Subject: Response to EG&G and Staff Comments on Topical Report No. CENPD-255.

FORMAL RESPONSES TO EG&G COMMENTS

EG&G COMMENTS/C-E RESPONSE

Figure B-7A
TYPICAL CONTAINMENT BUILDING ENVIRONMENTAL TEST PROFILE
FOR CATEGORY "A-1" AND "A-2" ENVIRONMENTAL CONDITIONS

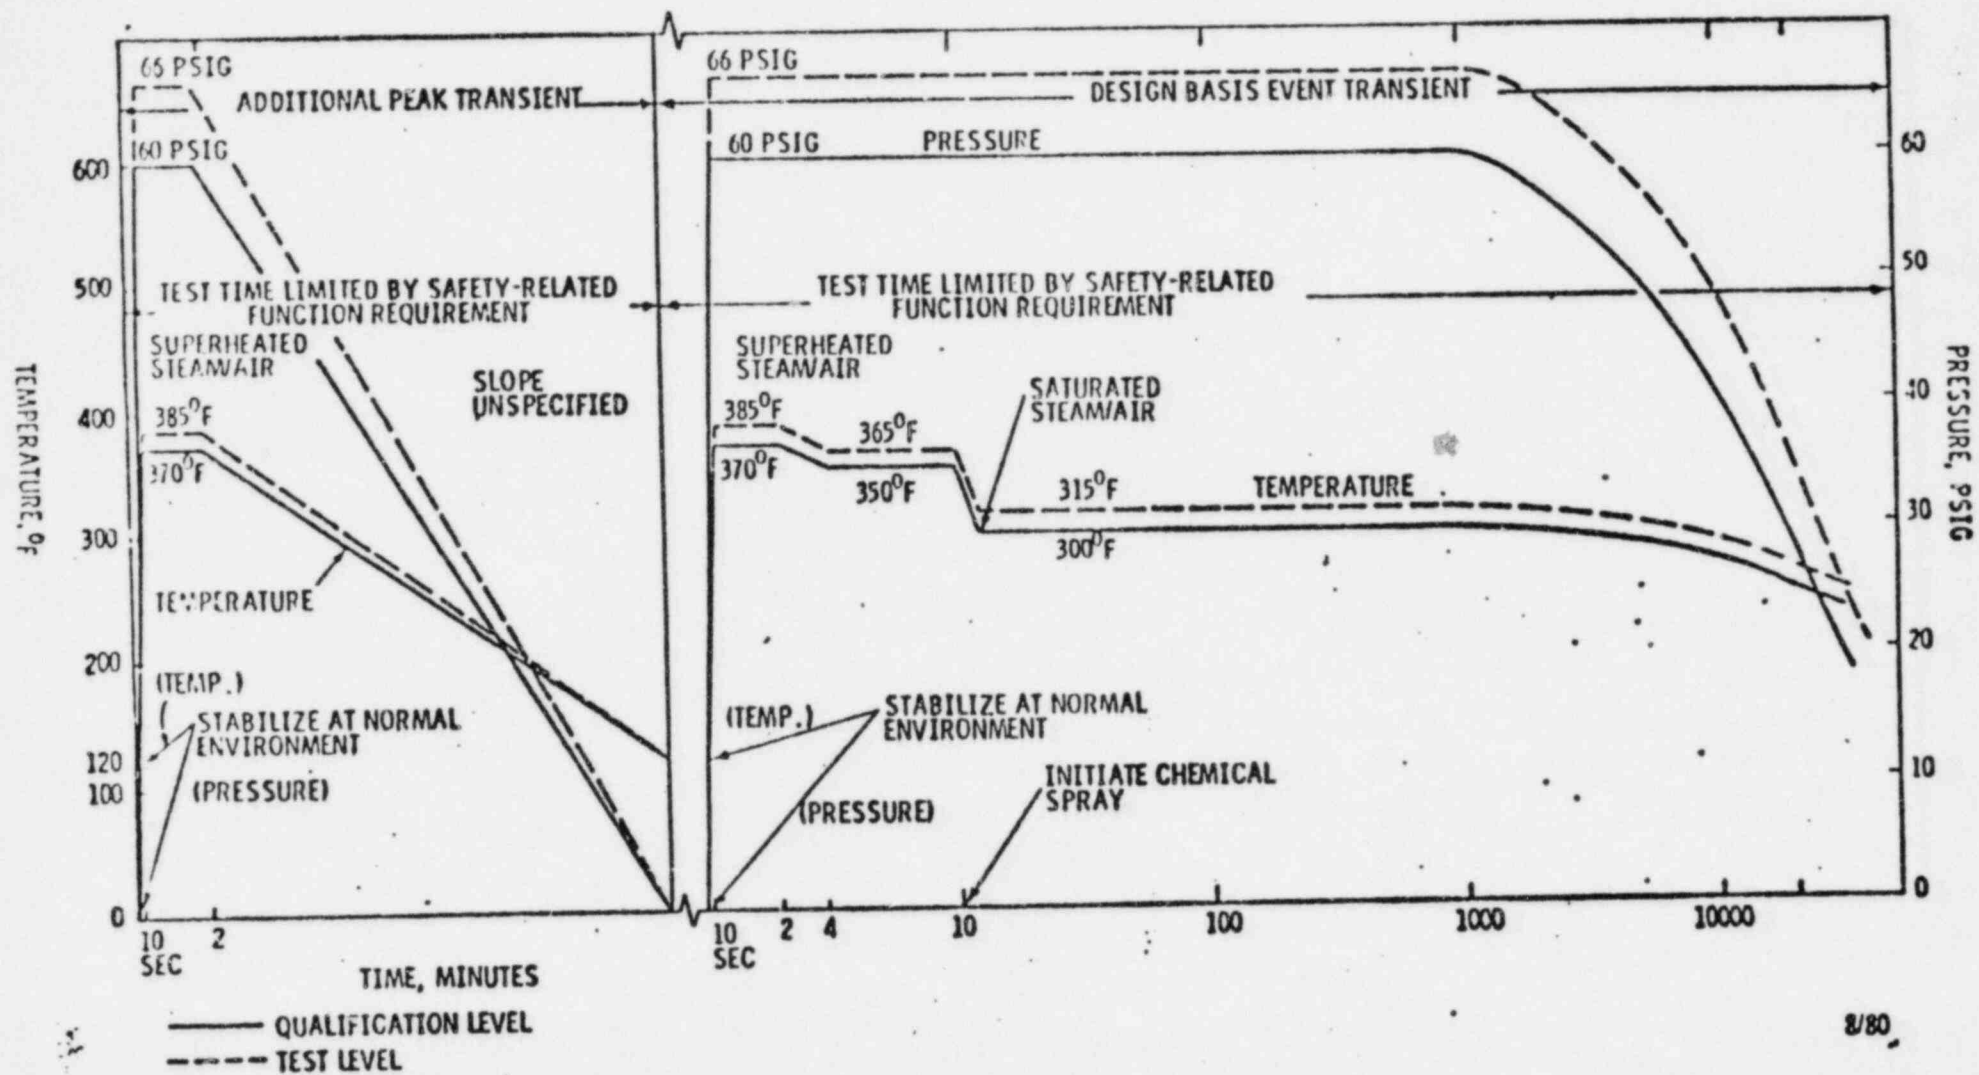
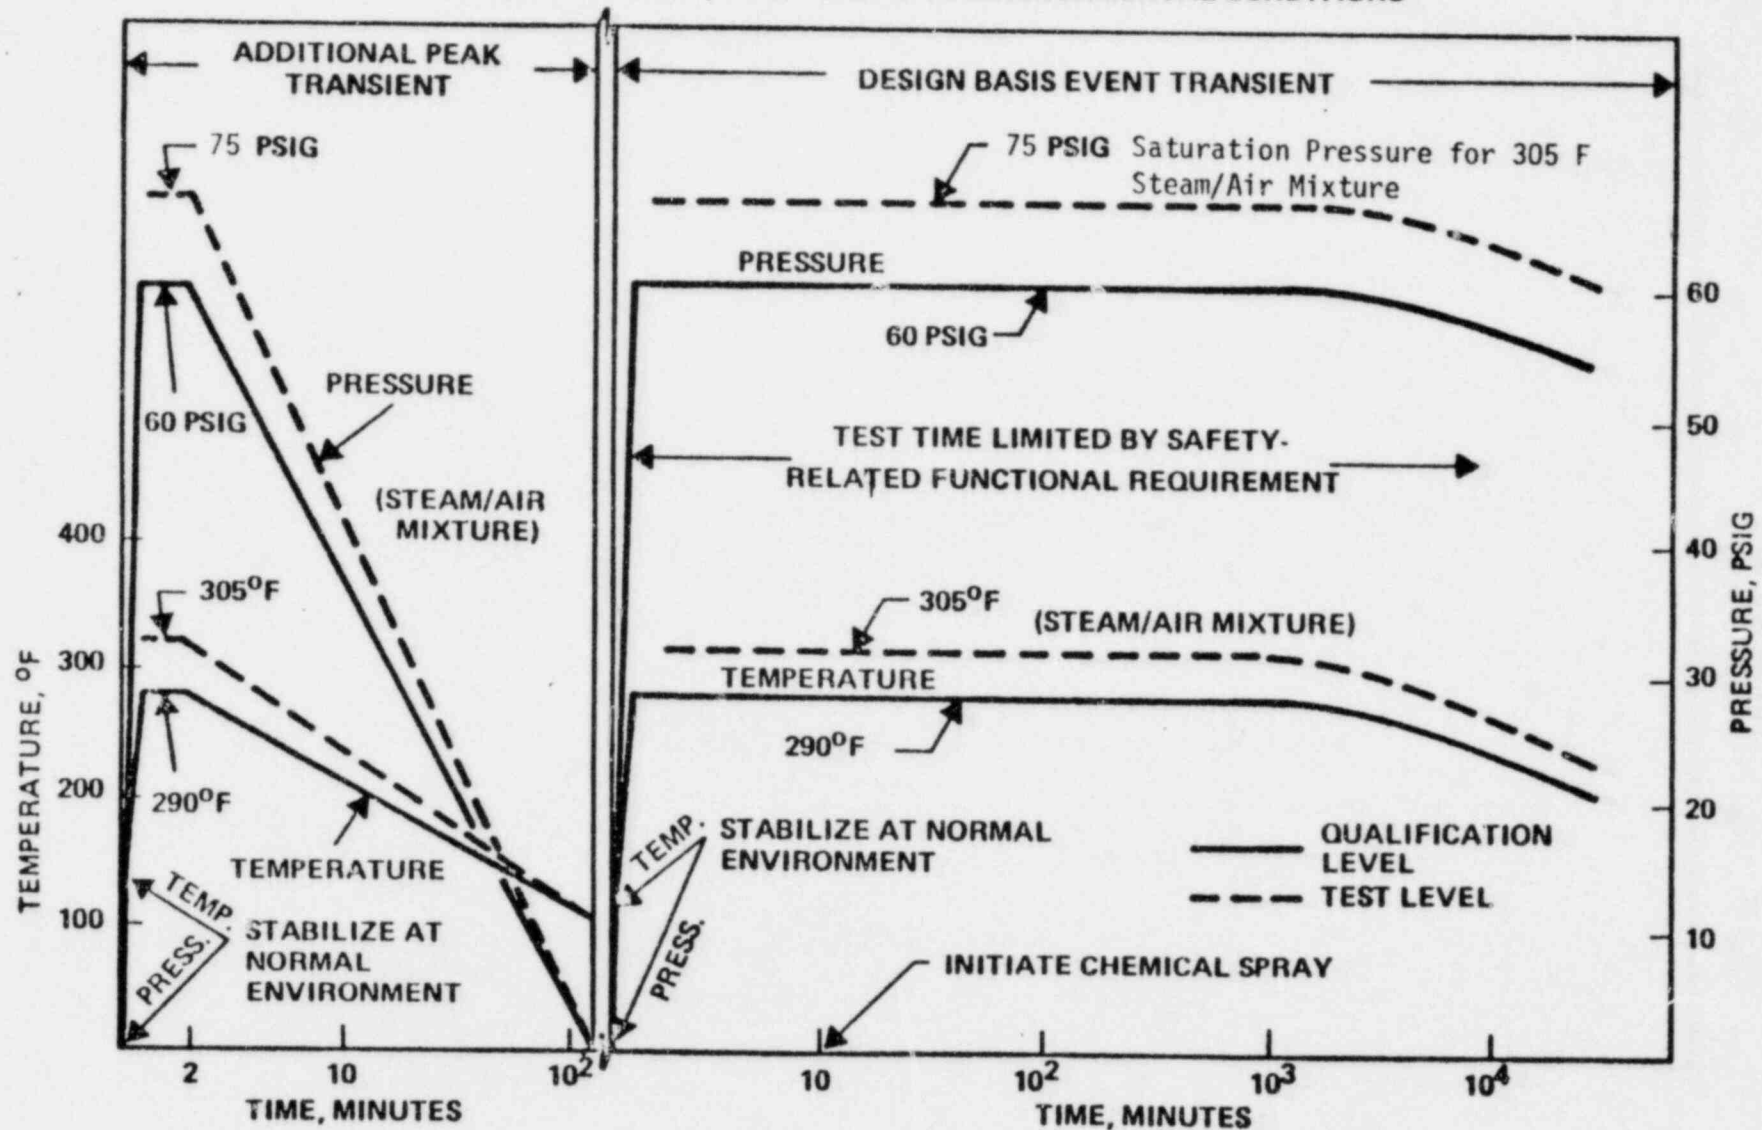
See review of Section 3.4.1.1 for discussion of Figure B-7.

Figure B-7. This typical test profile is intended to envelope equipment in environments shown in Figures B-1 through B-6. The maximum test temperature is 305°F, which is to include 15°F for margin. The maximum temperature shown in Figure B-1 through B-6 is 370°F. This indicates that a test temperature including a 15°F margin would be at 385°F. The reviewer assumes that 290°F (the test temperature without margin) was derived as the saturation temperature for 60 psig. The reviewer also assumes that this was done in accordance with IEEE 323-1974, Section 6.3.1.5(1). This method was incorrect since this IEEE section applies to margin only, and then only in the case where saturated steam is to be used. In this case, the in-containment humidity is specified as superheated steam, which then forces a high temperature than saturation unless the higher pressure (to meet saturation for the required temperature) is used.

The following wording has been added to Section 5.1.3:

As stated in Section 3.4.1.1, Figures B7A and B7B define the environmental test profiles for in-containment equipment. The combined MSLB/LOCA profile of Figure B-7A has a 15°F temperature and 6 psig pressure margin added which is illustrated with a dotted line.

A 15°F temperature and corresponding 15 psig saturation pressure margin were added to the saturation temperature and pressure values resulting in the environmental test profile illustrated by the dotted line in Figure B-7B.

See Section 3.4.1 write-up. Figure B-7 has been replaced with Figures B-7A and B-7B.

Figure 3.11A-1A
TYPICAL CONTAINMENT ATMOSPHERE TEMPERATURE CONDITION
FOLLOWING LOCA

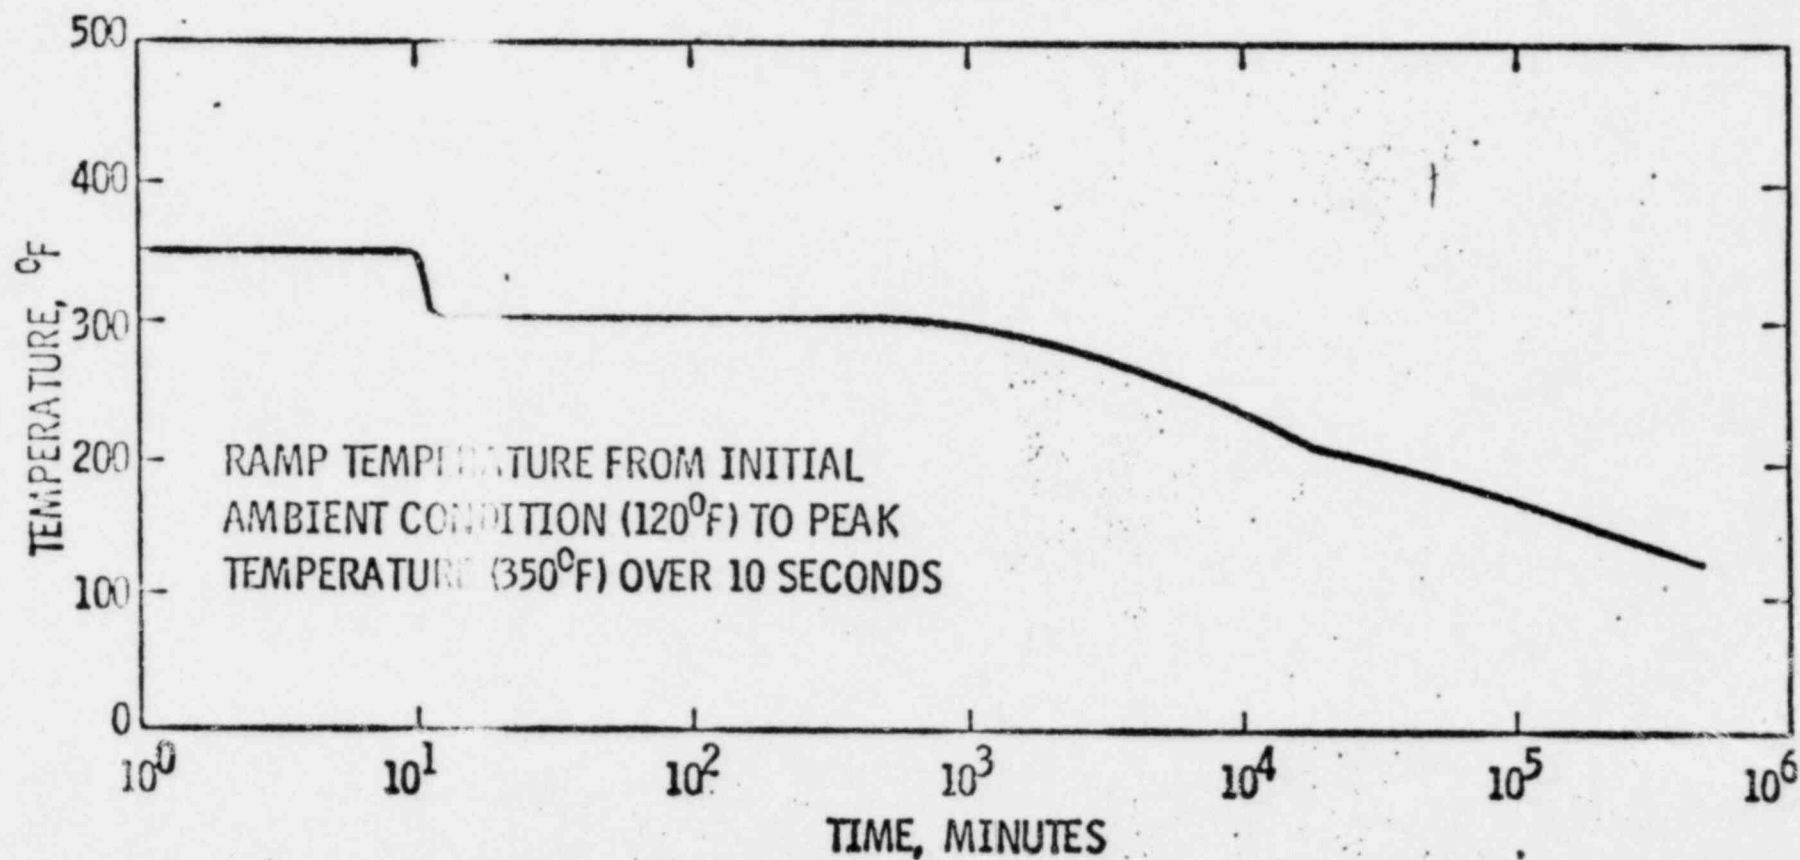
It is also noted that CESSAR FSAR, Figure 3.11A-1A (LOCA Temperature) is identical to Figure 3.11A-3 (MSLB Temperature). Is this correct?

Figure B-1. This figure shows a 200° elbow at about 44 hours. CESSAR Figure 3.11A-1A shows this elbow at about 264 hours.

Figure B-4. This figure has a peak of 370°F. CESSAR Figure 3.11A-3 does not show a 370°F maximum. (This CESSAR figure is a duplicate of CESSAR Figure 3.11A-1A).

This comment will be addressed in the revision of Section 3.11.

FIGURE 3.11A-5

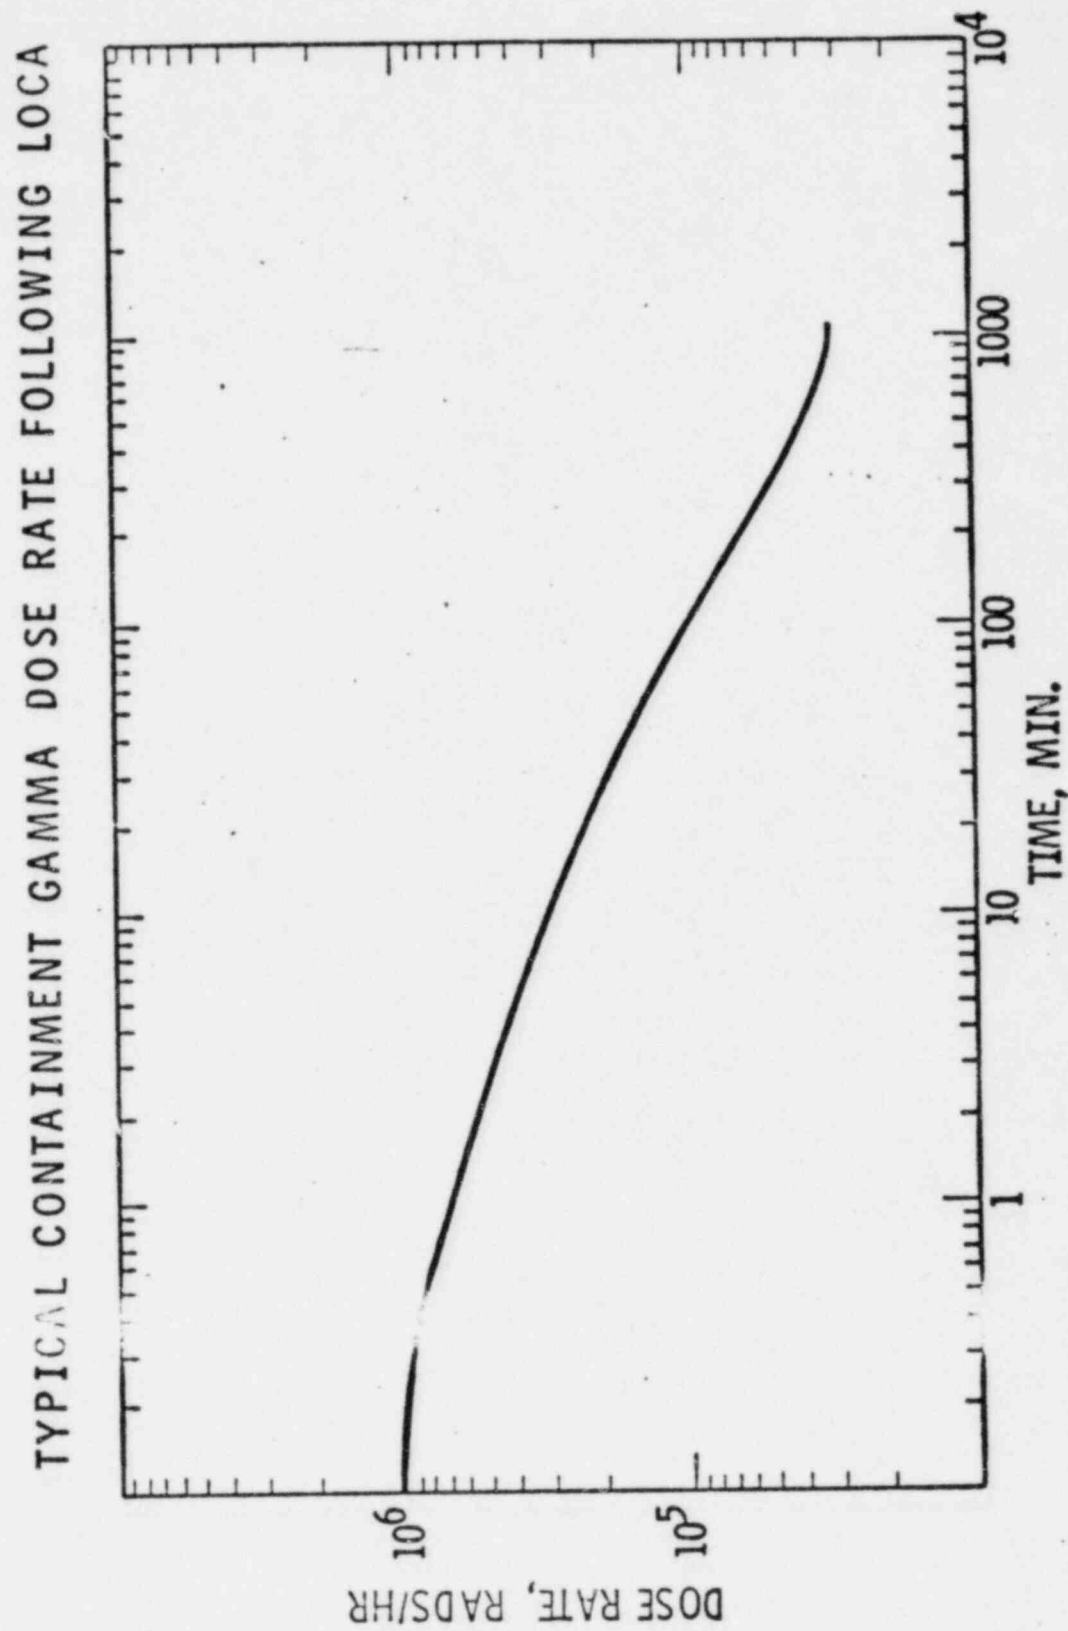
Figure B-6. This figure shows about one-half of Figure 3.11A-5 CESSAR values.
